D5 Architects

Providing evidence in response to reason for refusal;

Design Evolution_Pre Application Advice

Recap on Reason for Refusal

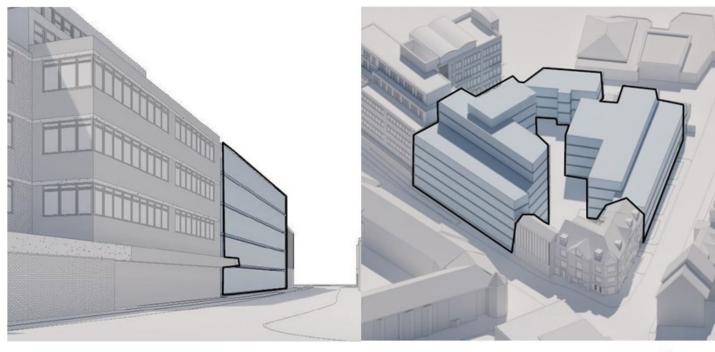
Generally supported but too 'intense' and set back top floors with terraces to the street are 'bad townscape' and will not be accepted.

Reduced height of Block A

Removed flat roofs and terraces for pitched roofs more in keeping with the location.

Reduced the scheme from 3 residential blocks to 2 residential blocks.

Design Evolution_High Street Elevation Height

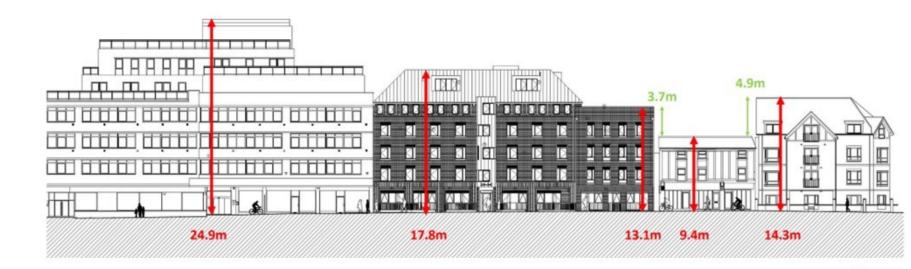
BCC provided a datum for their preferred height of the High Street facade.

The appeal design largely matched the BCC proposal and the City Design Manager noted that the matters regarding the height of the scheme had been addressed.

Illustration of the relative heights and steps to the lower Cardamon Restaurant

Design Evolution_Harborne Park Road Elevation

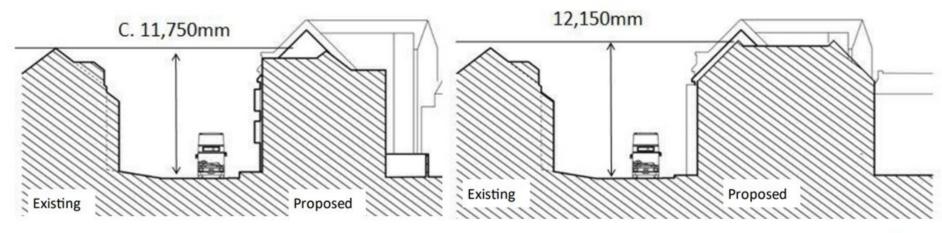
BCC provided a datum for their preferred height as the height of the previously consented scheme.

The previous consented scheme height relative to the xisting houses opposite is illustrated below left with the appeal scheme height illistrated below right.

The appeal scheme is 400mm higher which we do not regard as detrimental to the houses opposite.

Recap on Reason for Refusal_Amenity Space

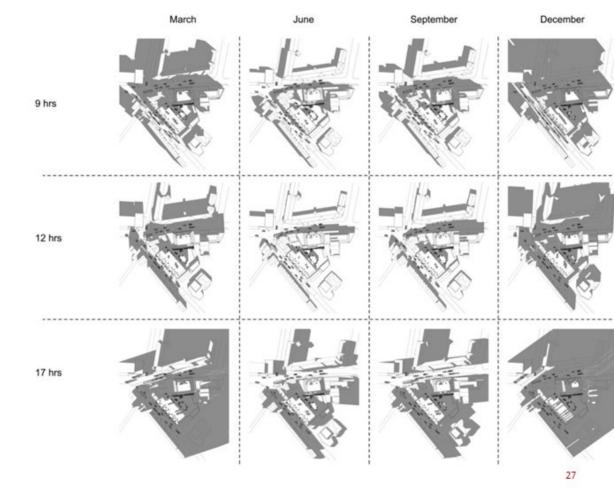
- Poor quality 'left over' space to the courtyard impinged by traffic and odours from the bin store
- Lack of sunlight into the courtyard
- Unbalanced provision with too much space allocated to private amenity
- Noise impacts of traffic making the roof terrace to Block A unusable.

Quantum exceeds the Design Guide requirement

Design predates the SPD so we were unaware of requirements and offset between communal and private

Landscape conditioned for detail approval can resolve this

Bin store maintained by management company will be cleaned and emptied weekly reducing odours
